**Ship Simulation Transit Scenario Modeling & Ship Pilot Study of the
Maritime Implications for Commercial Ship Transits of the Proposed
Houston Ship Channel Gate Complex**

Prepared for:
Greater Houston Port Bureau

Report Version 7.2, 11/30/2022

Figure 17. Run #33, Setup two outbound ships transiting south gate, inbound ship transiting north gate to Galveston, Ebb current (2.5) knots, wind at 335 degrees at 30 knots, daylight

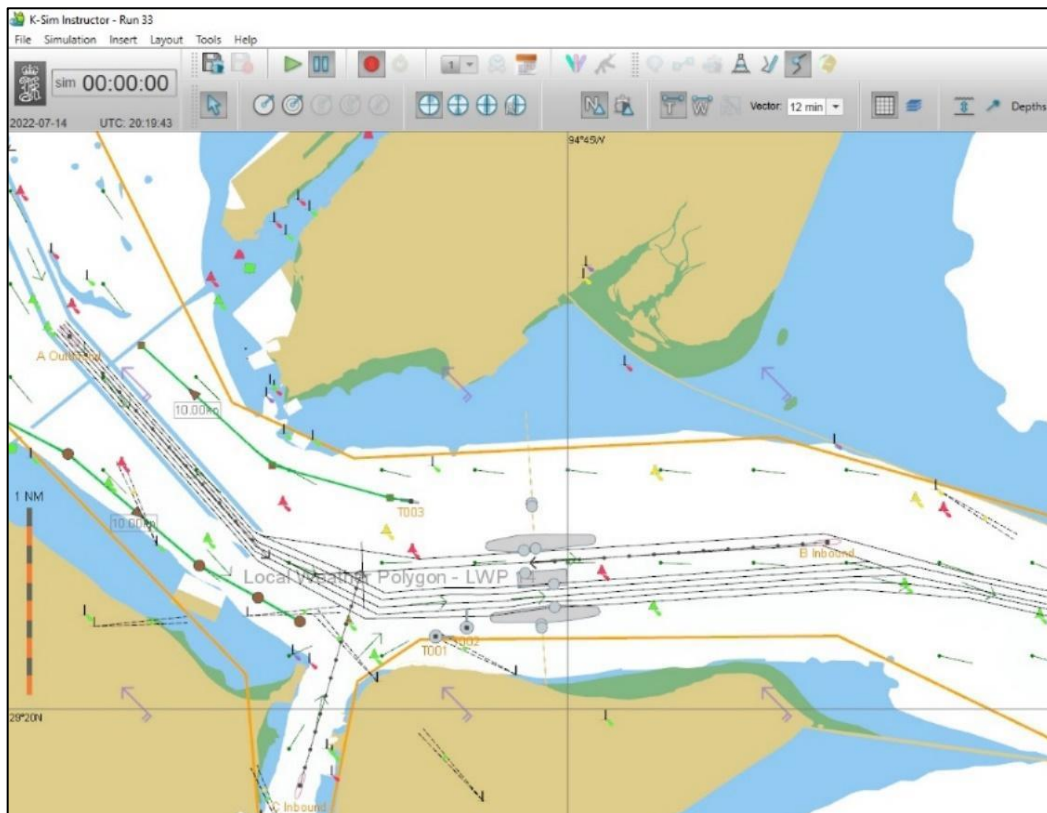
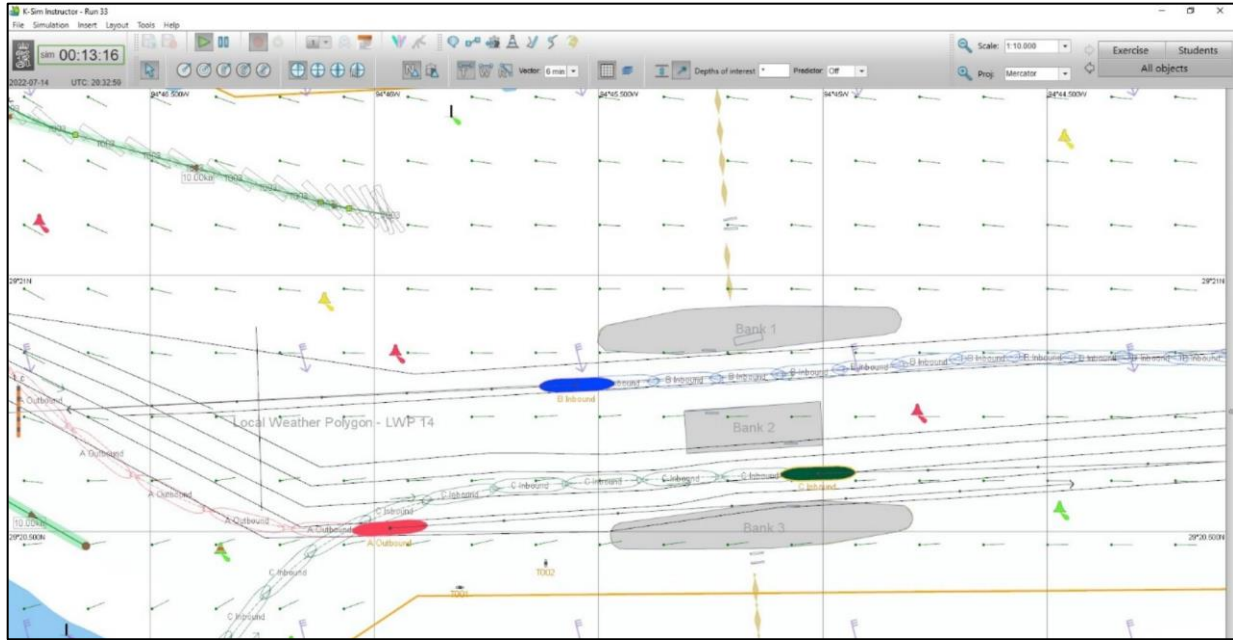
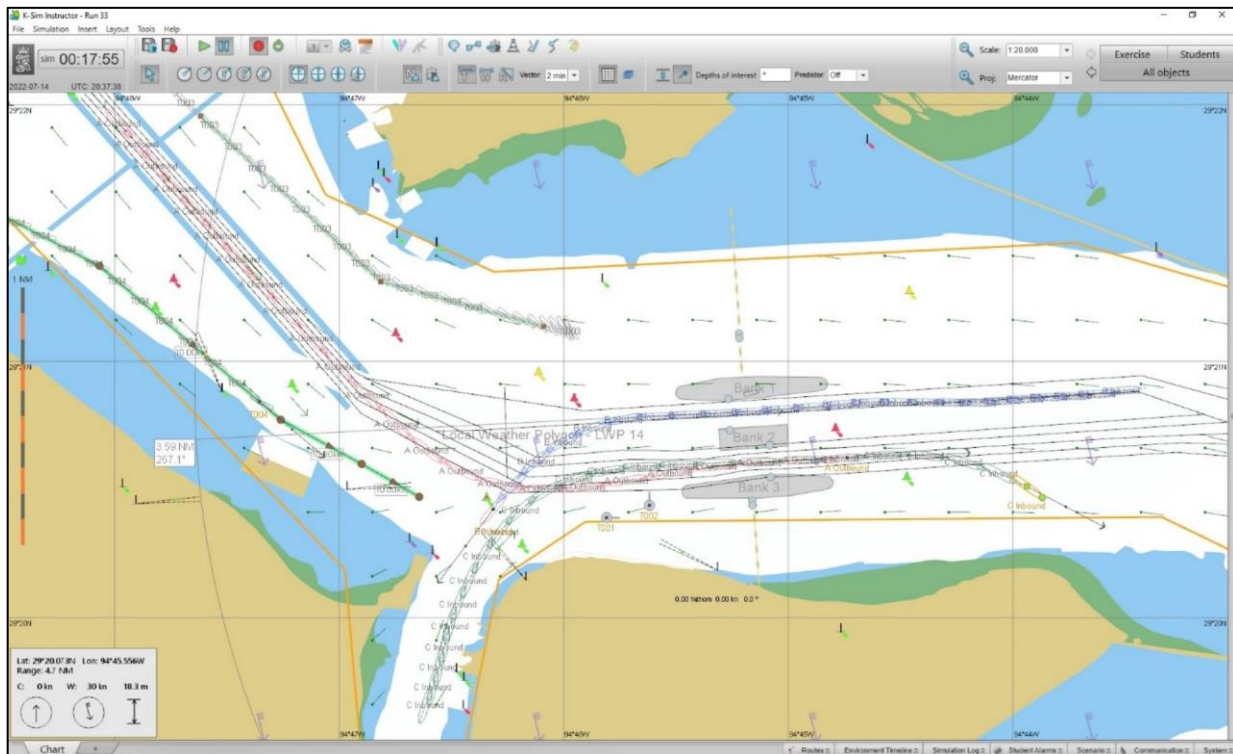
The result of this scenario is a GAR score of 2 Caution. Both outbound ships from HSC and Galveston entered the south gate at an angle and traveled across the center line in the gate. This was most pronounced for the ship outbound from HSC that transited from below the center line after performing the turn at buoy 16 to transiting above the south gate centerline extension. The inbound ship transited above the center line in the gate in order to limit the angle and thus make a safer and easier turn into Galveston Channel. Transiting off the center line in the gates and especially at an angle is a potential hazard as shown above in Figures 4 and 5. This is because the walls in the gate system cause shearing forces, and if the ship is unaligned, it can cause the ship to lose control as shown in Figure 5.

Figure 23. Run #35, outbound ship from HSC nearly allides with center island of gate system due to losing engines from shearing bank effect

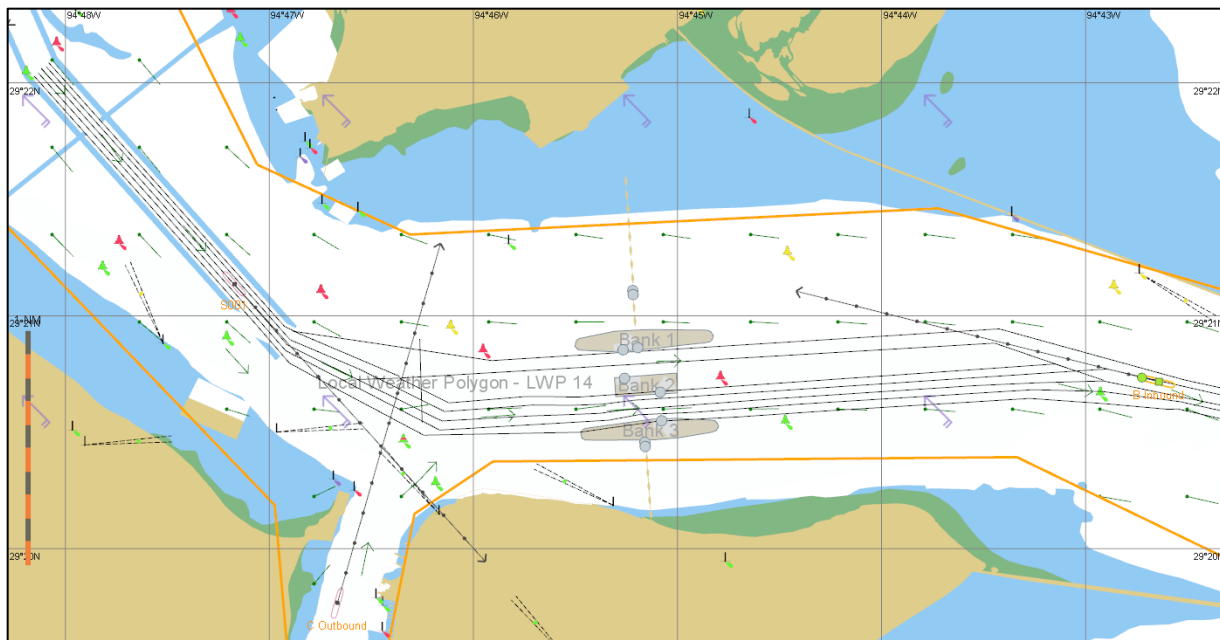
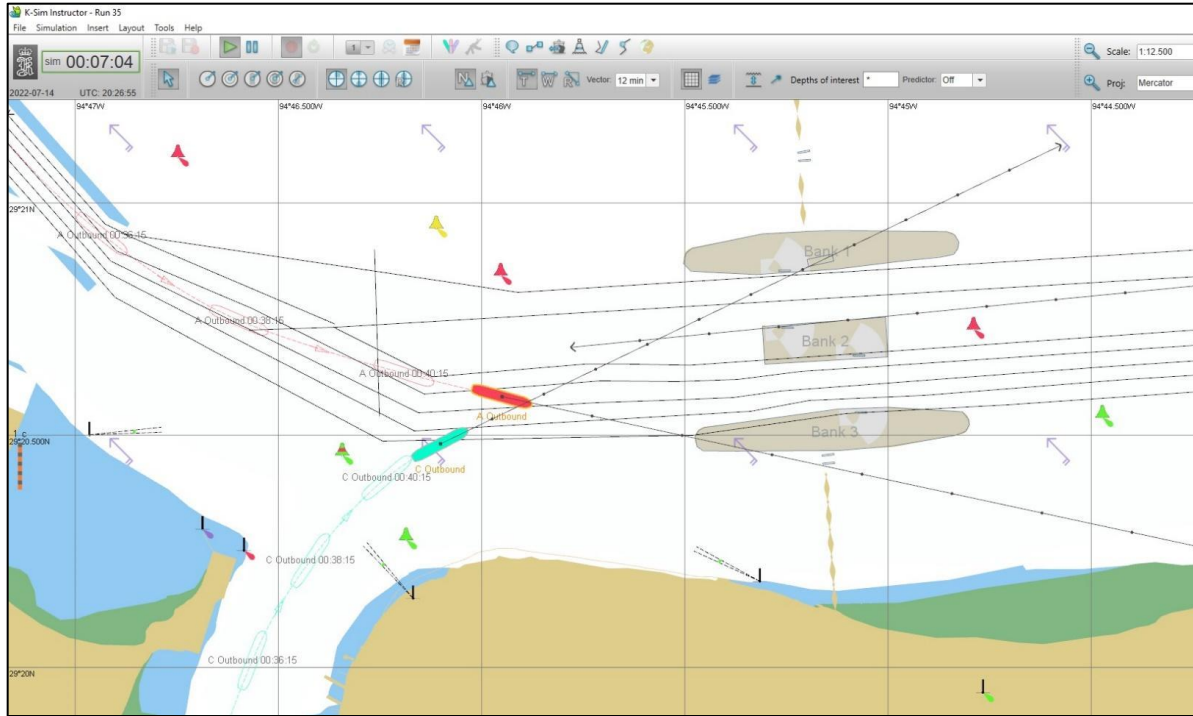
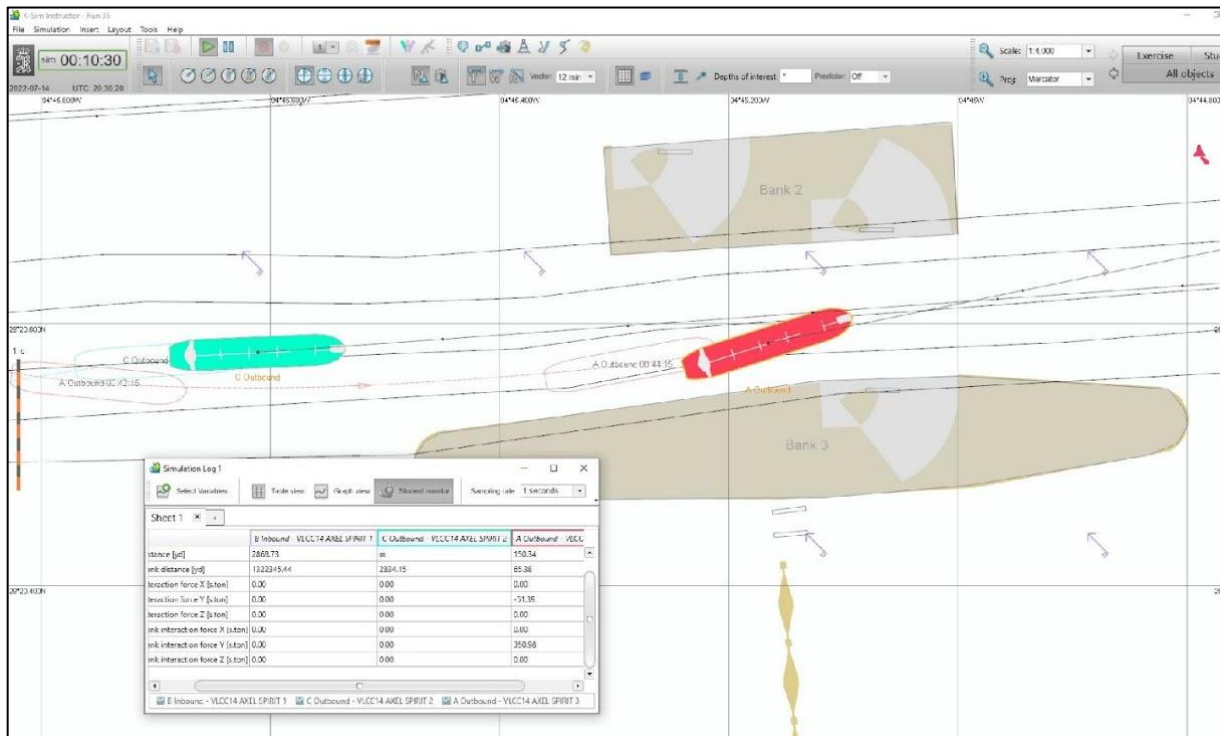
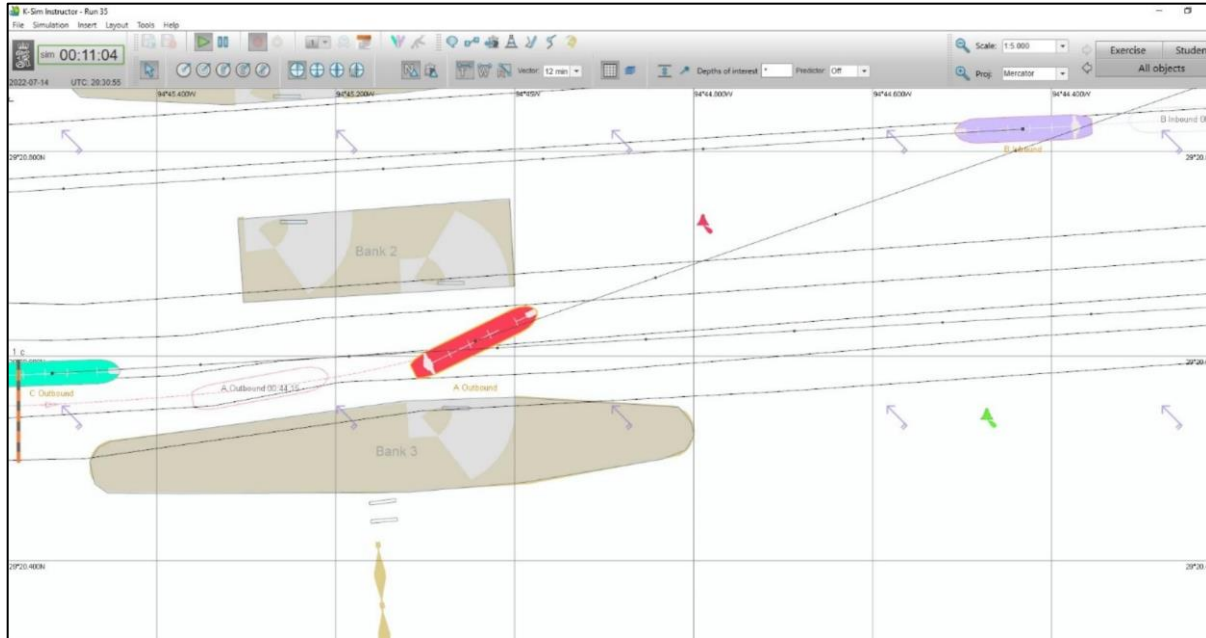
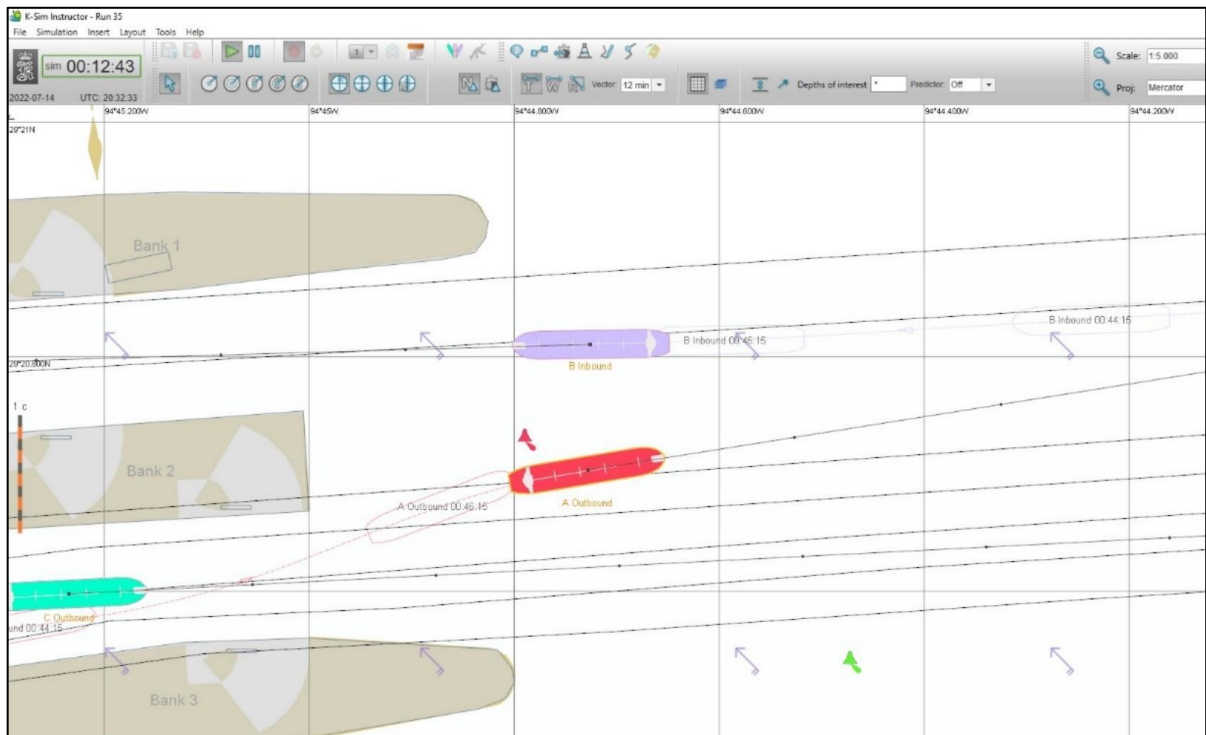
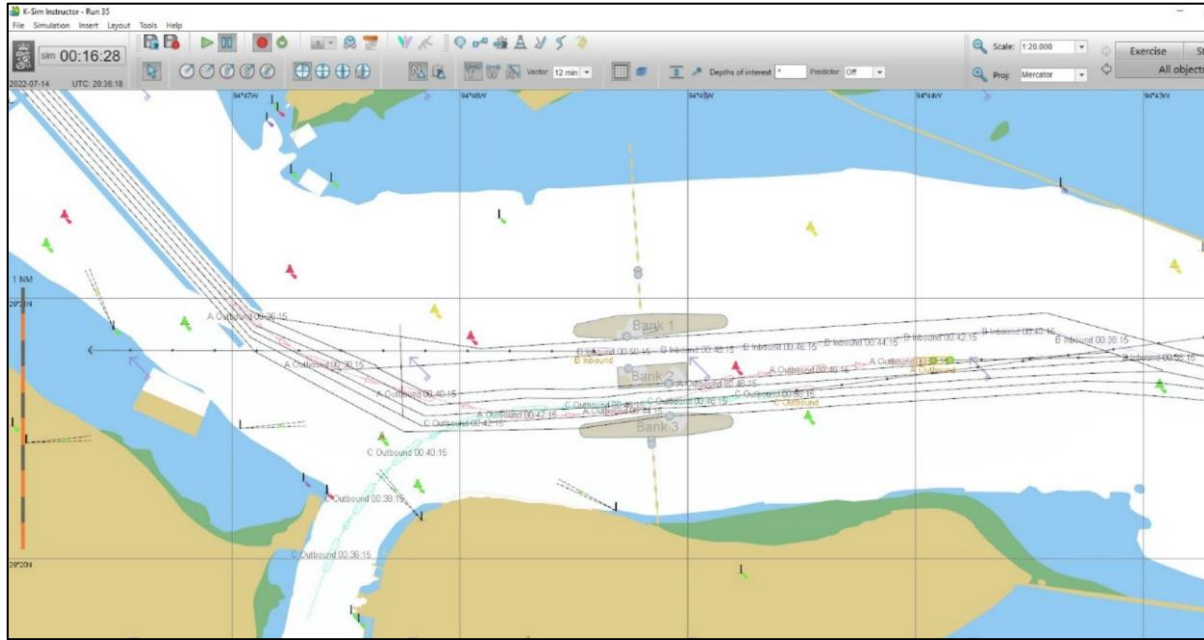
During run #35 there were multiple near collisions between ships and an allision between an outbound ship and the gate system. The scenario was an outbound ship starting above buoy 18 in the HSC, an outbound from Galveston Channel starting about a mile from the HSC intersection. Both outbound ships are to transit through the south gate. The inbound ship is to transit through the north gate. The VLCC14 model is used for all ships. There is an ebb current (2.5 knots) and wind is 135 degrees at 20 knots during daylight.

The result of this scenario is a GAR score of 3 High Concern. Both outbound ships from HSC and Galveston almost had a collision on approach to the south gate. Emergency ship handling was required. This caused the outbound HSC ship to enter the south gate system misaligned and at an acute angle. The piloted ship, experiencing shearing forces from the bank and attempting to not have an allision with the gate, had a near allision with the center island of the gate system. Again, emergency ship handling was required. The pilot aboard the ship outbound from HSC describe the maneuver as very unsafe and described losing control of the ship due to bank effect. Fortunately, they were able to regain control before colliding with the inbound ship transiting into the north gate.

Figure 26. Run #42, setup outbound ship in HSC transiting to south gate, two inbound ships transiting to north gate, ebb current (2.5 knots), wind 135 degrees at 20 knots, daylight

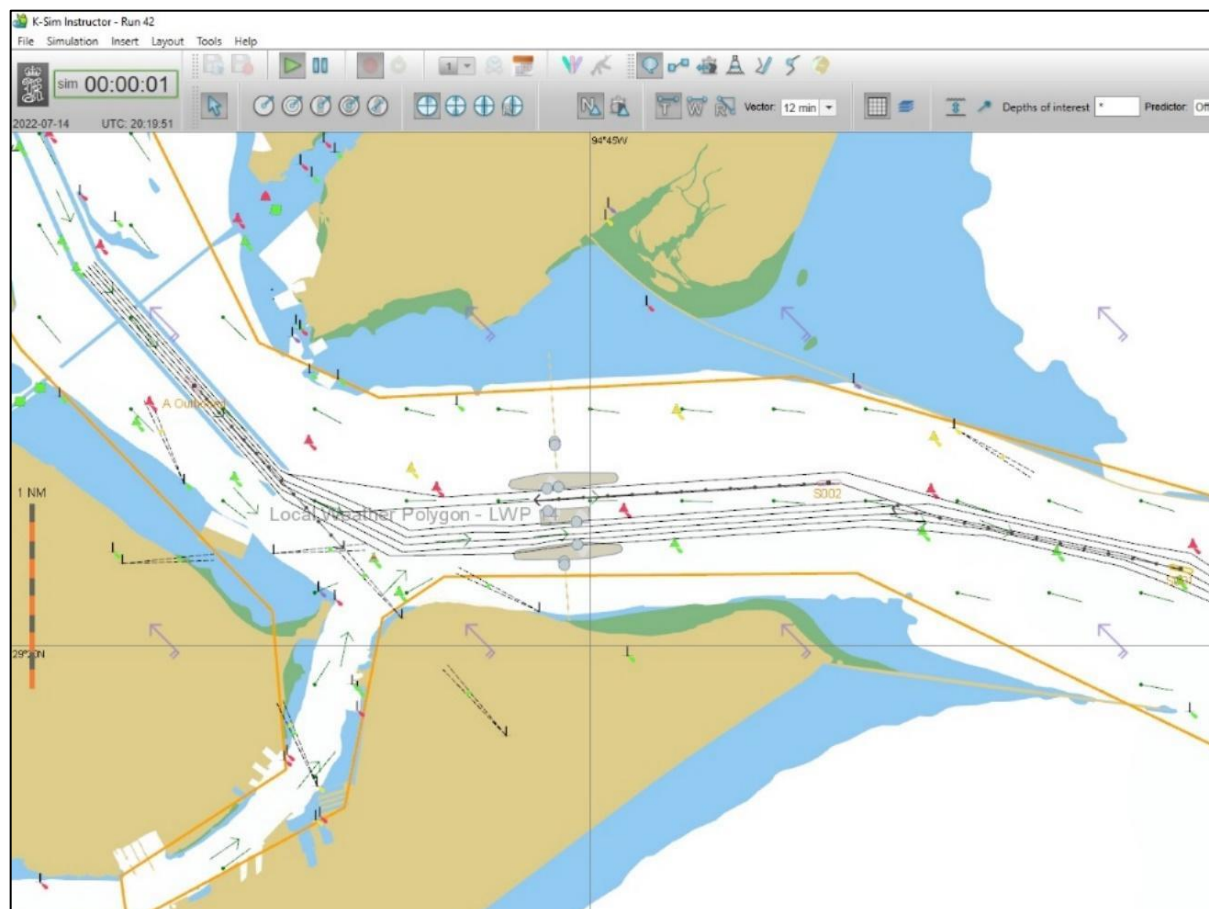
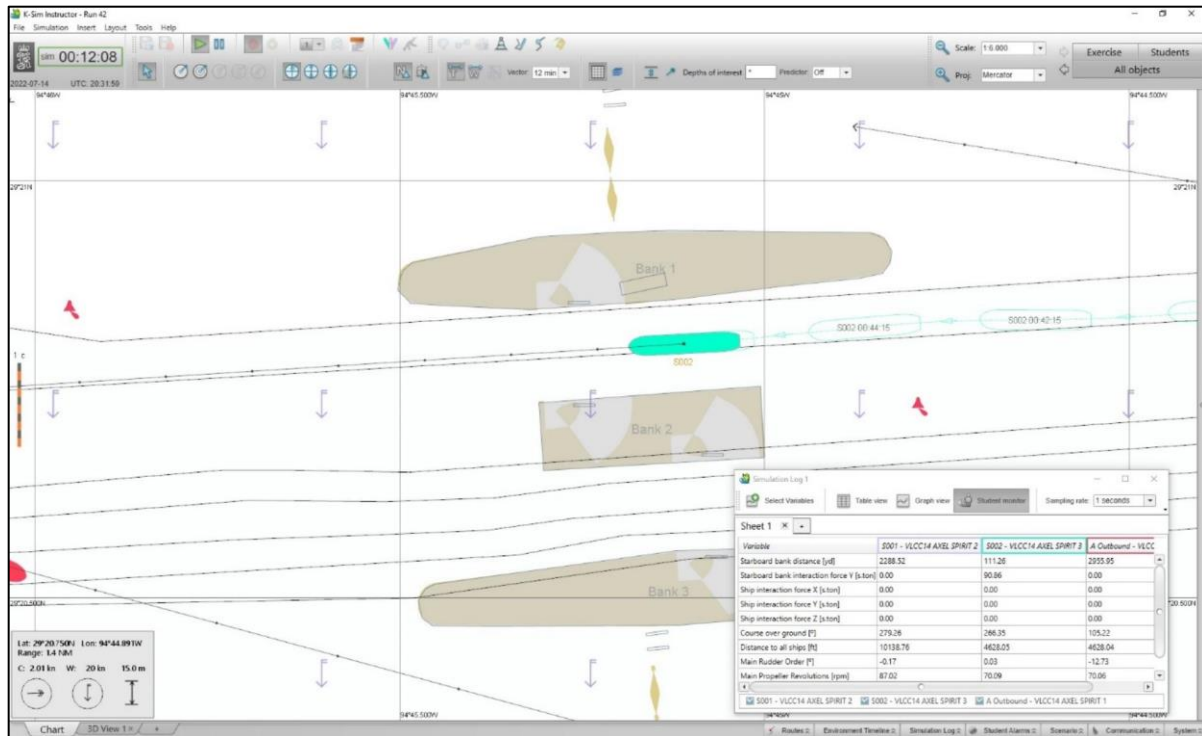
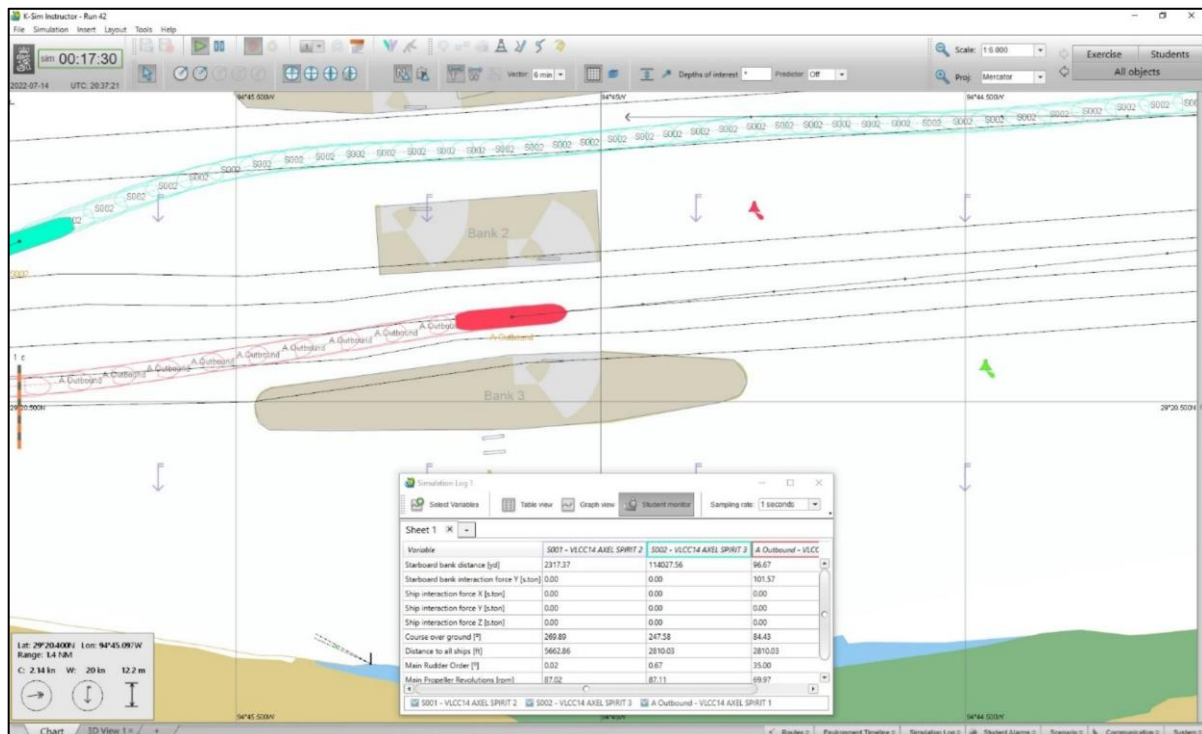
Run #42 was another scenario with both gates open using an ebb current (2.5 knots). This scenario also used VLCC14, the wind is 135 degrees at 20 knots, and it was during daylight. There were two inbound ships and one outbound ship used in this scenario. The inbound ship experienced shearing forces from the bank even though it was on the center line as it passed through the north gate. The outbound ship was misaligned when passing through the south gate, and experienced strong shearing forces from the bank. The result of this scenario is a GAR score of 2 Caution.

The result of these maneuvers led to multiple recommendations from the pilots. They stated that the gates need to be widened. This is to prevent the shearing forces on the ships when
